Supplement

Manual Title:	DSP-LIA101 I.S.	Supplement Issue:	1
Part Number:	1605844	Issue Date:	8/01
Print Date:	April 2001	Page Count:	1
Revision/Date:

This supplement contains information necessary to ensure the accuracy of the above manual.

Figure 1. Handling Guidelines

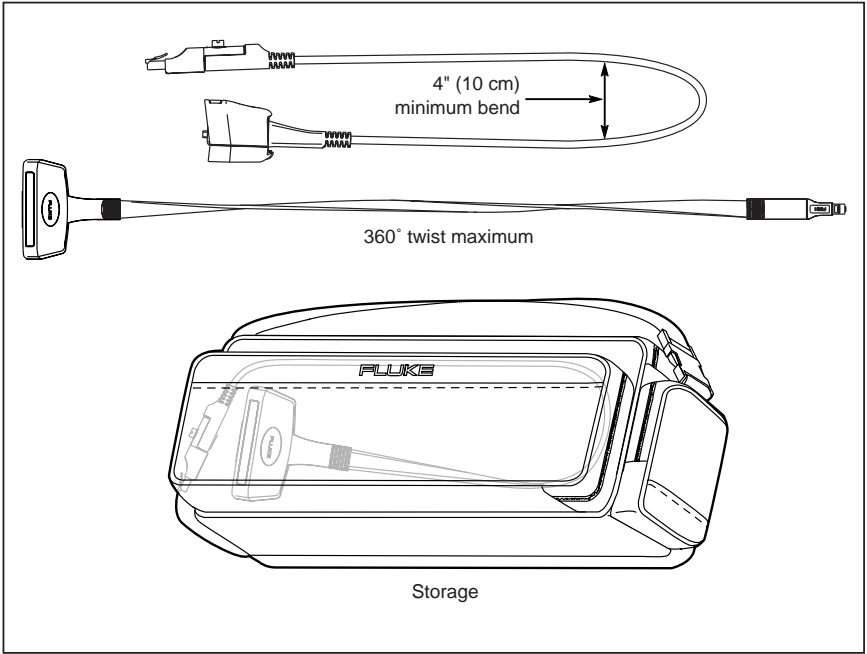
Change #1

Replace Figure 1 with the following:
